# SAFETY INFORMATION PCI 63000224

**Subject:** Instruction PCI N°63000224 sent by TKEMS

ThyssenKrupp Elevator Manufacturing Spain		<b>ThyssenKrupp</b>
<b>PRODUCT CORRECTION INSTRUCTION</b> <b>OVERSPEED GOVERNOR SG-200 &amp; SG-300 ELECTRIC CONTROL FAULTY</b>	No.: PCI 63000224 Rev. 01 Page: 1 DATE Rev. 00: 21/07/2014 DATE Rev. 01:17/09/2014	
<p><b>1. FAULT</b></p> <p><b>1.1. Description</b></p> <p>During the mandatory commissioning test prescribed EN-81-1, Annex D, section D.2, paragraph i in one elevator it has been detected that the electrical switch of the Overspeed Governor SG-200 is not actuated when the elevator is moving in upwards direction at tripping speed, so that the safety line is not open and therefore the machine brake do not stop the car, as is defined in the EN-81-1-1 part 9.9.11.1.</p> <p><b>1.2. Reason</b></p> <p>Due to this customer complaint the failure was analyzed with the conclusion that some version of the Overspeed Governor SG-200 and SG-300, that includes the electrical switch XCM 2110S38 and XCM2910 S38; under two joint circumstances the electrical switch could fail.</p> <p>These two circumstances are:</p> <ul style="list-style-type: none"> <li>- Misali

2.2.1. Readjustment of the cam actuator

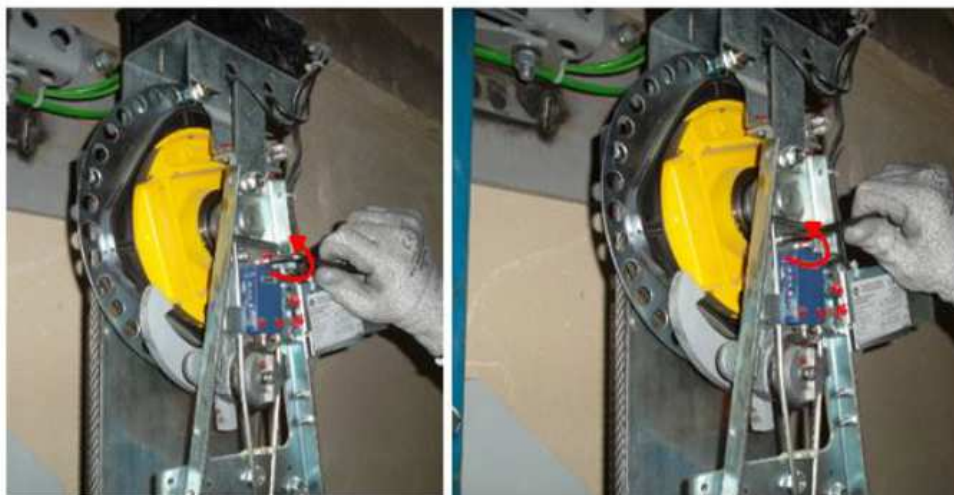
2.2.1.1. Loosen half turn the screw of the cam actuator indicated in the picture

2.2.1.2. Push the cam actuator to its top position.

2.2.1.3. Tighten the screw of the cam actuator

#### On MC3 controller for the Synergy NC91A :

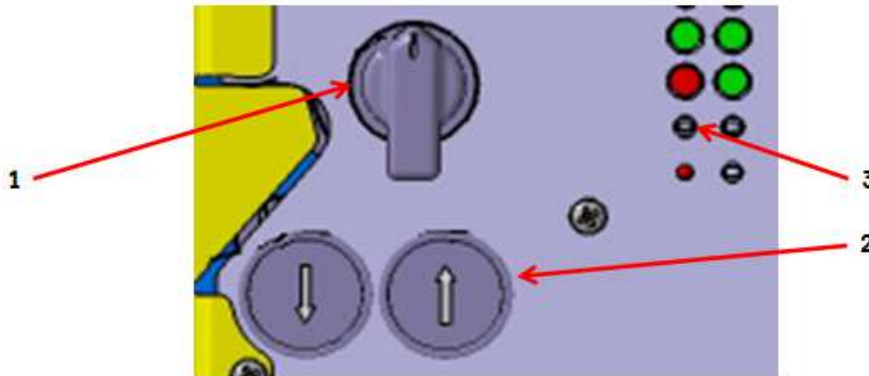
- Put the switch « Normal/Recall » on to Recall (S01 on 1, see ref **1**),
- See the electrical wiring diagram of the lift file,
- Switch off the circuit breaker F02 (check absence of voltage between terminals X2.N and X1.115 with a Voltage Detector),
- Disconnect the 2 wires, of the over speed governor contact cable, from terminals X1.115 and X1.120 located at the bottom of the service box (reconnect the 2 wires on a connection terminal strip),
- Put the circuit breaker F02 back to normal,
- Put a continuity tester on the 2 above wires previously disconnected (use the connection terminal strip),

- Make a call in the upwards direction (press the S01F button , see ref **2**),
- During the run, engage the safety gear (press the safety gear button S25, see ref **3**).

If the tester sounds, please refer to chapter 2.2 ADJUSTMENT OF THE OVER SPEED GOVERNOR CONTACT (see instruction PCI 63000224).  
If the governor contact is located on wall side with no access for adjustment, please dismantle it according to the maintenance manual 3017422.

## On MHC/ECOR controller for the Synergy NC91B :

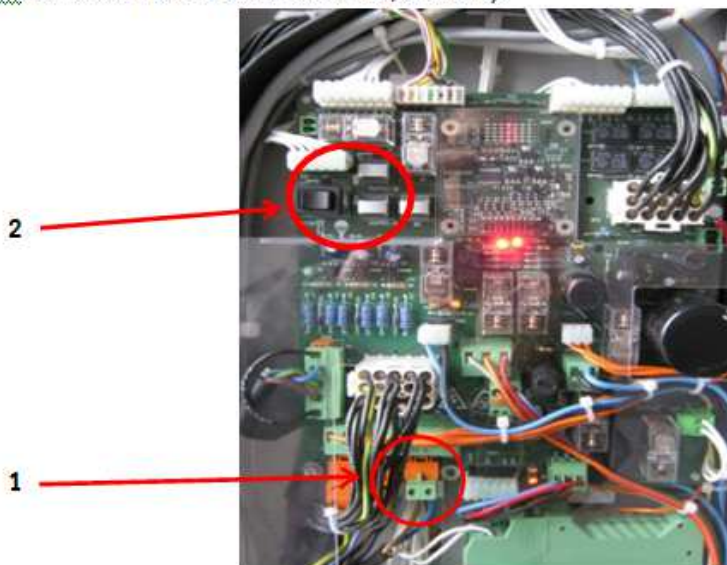
- Put the switch « Normal/Recall » on to Recall (S01 on 1, see ref **1**),
- See the electrical wiring diagram of the lift file,
- Switch off the circuit breaker F02 (check for no voltage between terminals X2.N and X1.115 with a Voltage Detector),
- Disconnect the 2 wires, of the over speed governor contact cable, from terminals X1.115 and X1.120 located at the bottom of the service box (reconnect the 2 wires on a connection terminal strip),
- Put the circuit breaker F02 back to normal,
- Put a continuity tester on the 2 above wires previously disconnected (use the connection terminal strip),

- Make a call in the upwards direction (press the S01F button↑, see ref **2**),
- During the run, engage the safety gear (using the MHC screen, go to the menu « 4. Diagnosis », « 2.TUEV tests », « 13.safety gear test », Type of governor : governor 1 (car) or governor 2 (counterweight), Mode: select « Manually », press « OK » to engage the safety gear).

If the tester sounds, please refer to chapter 2.2 ADJUSTMENT OF THE OVER SPEED GOVERNOR CONTACT (see instruction PCI 63000224).  
If the governor contact is located on wall side with no access for adjustment, please dismantle it according to the maintenance manual 3017422.
